STATE OF VERMONT
AGENCY OF TRANSPORTATION

RECORD PLANS

PROPOSED IMPROVEMENT
BRIDGE PROJECT

ROUTE NO : US ROUTE 2, RURAL MAJOR COLLECTOR. BRIDGE #32

1 S1.0 RIGID FRAME PLAN VIEW
¼" = 1'-0"

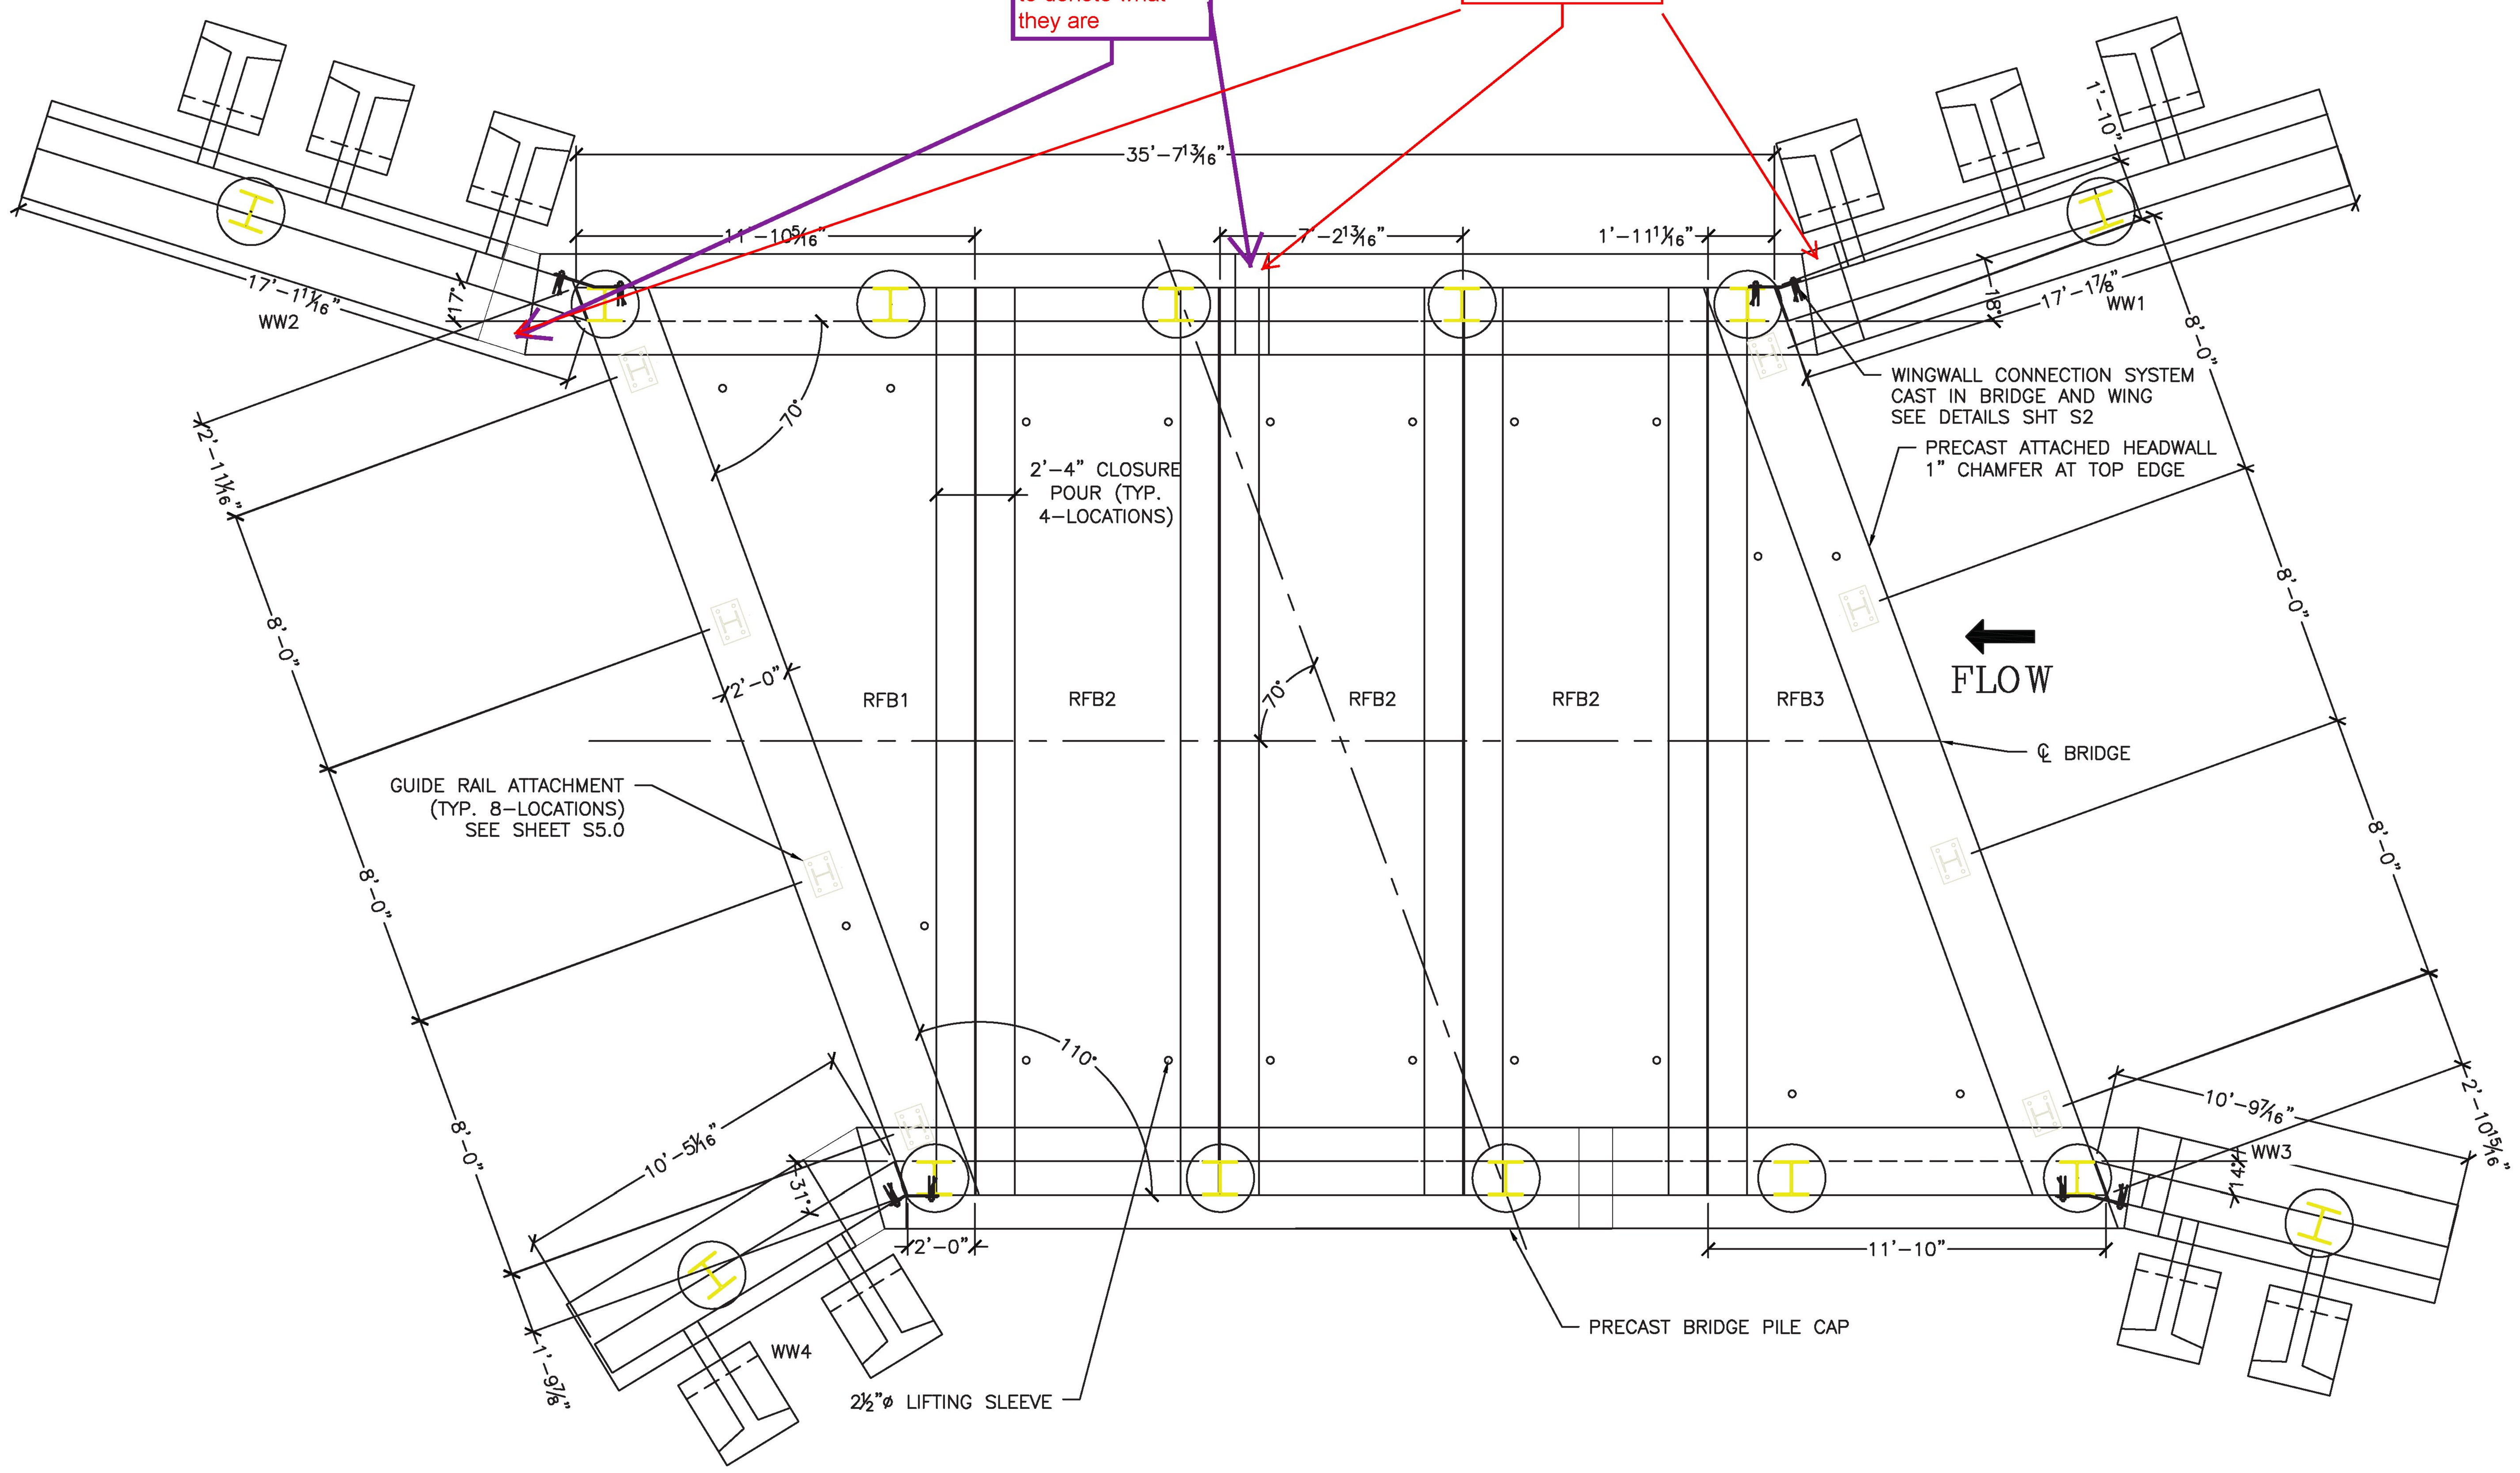
shade in the closure pour areas, like on sheet S 9.0, and label these areas to denote what they are

1 S3.4 APPROACH SLAB PLAN VIEW
1/4" = 1'-0"

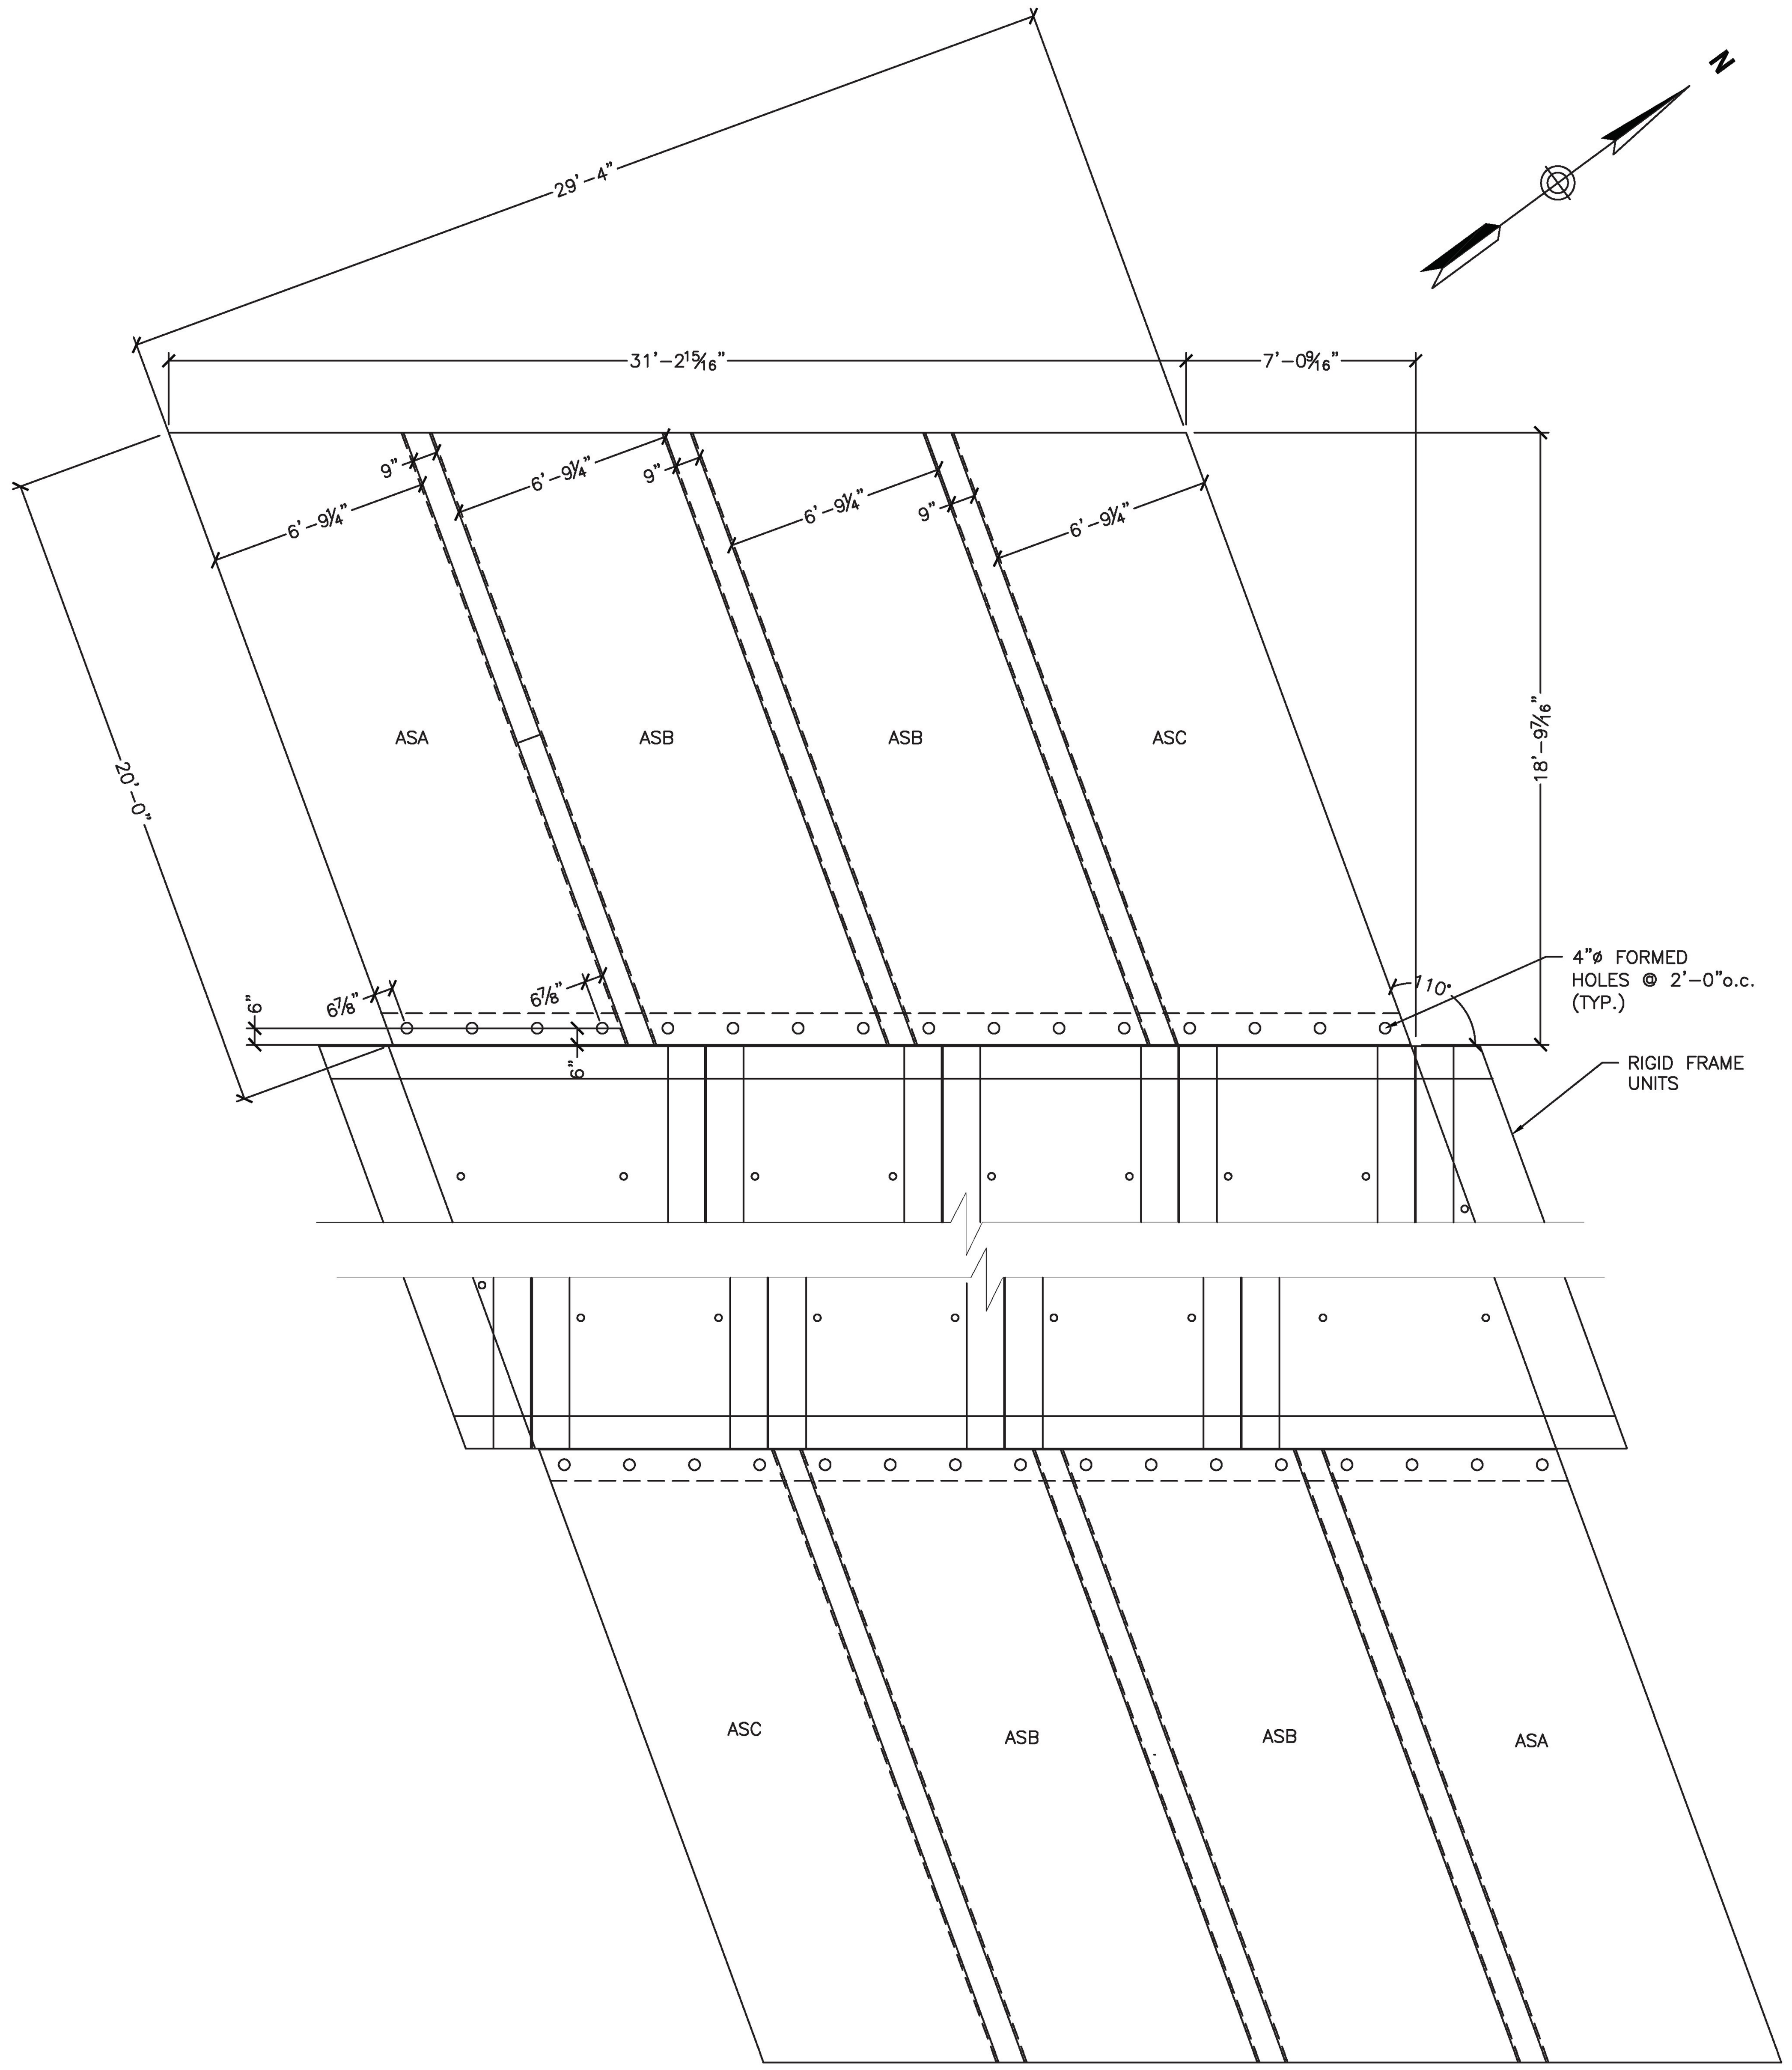
Contract plans sheet 3 note 34 says 1/8" exposed agg and indicate method used

3 S4.0 3 S5.0 TYP. REINFORCING SECTION
½" = 1'-0"

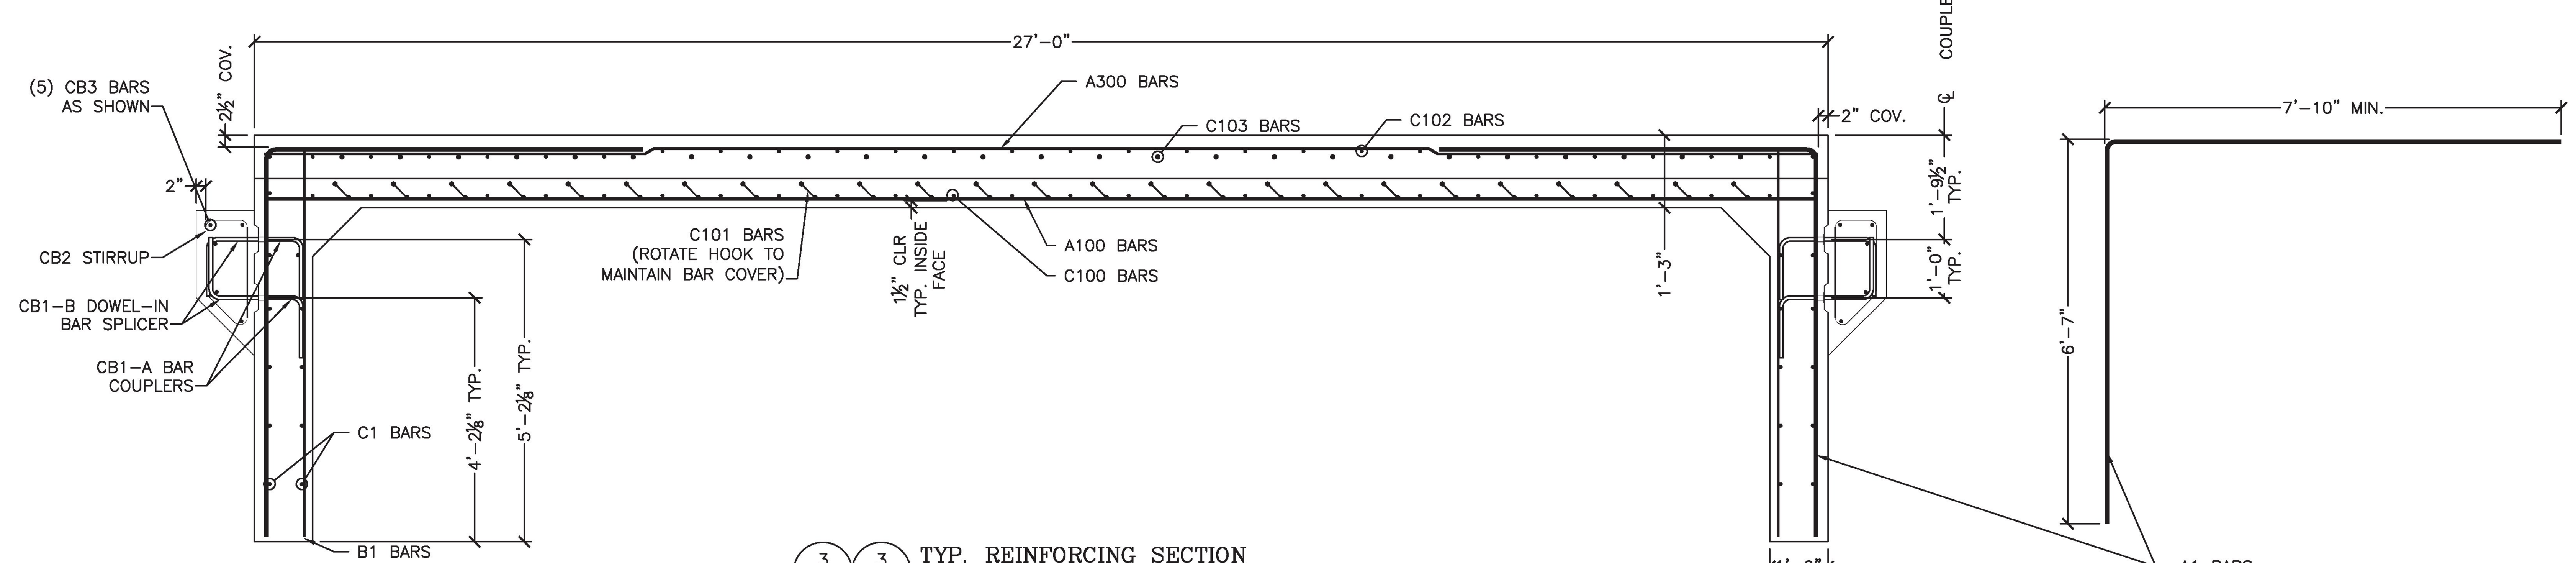
Verify quantity
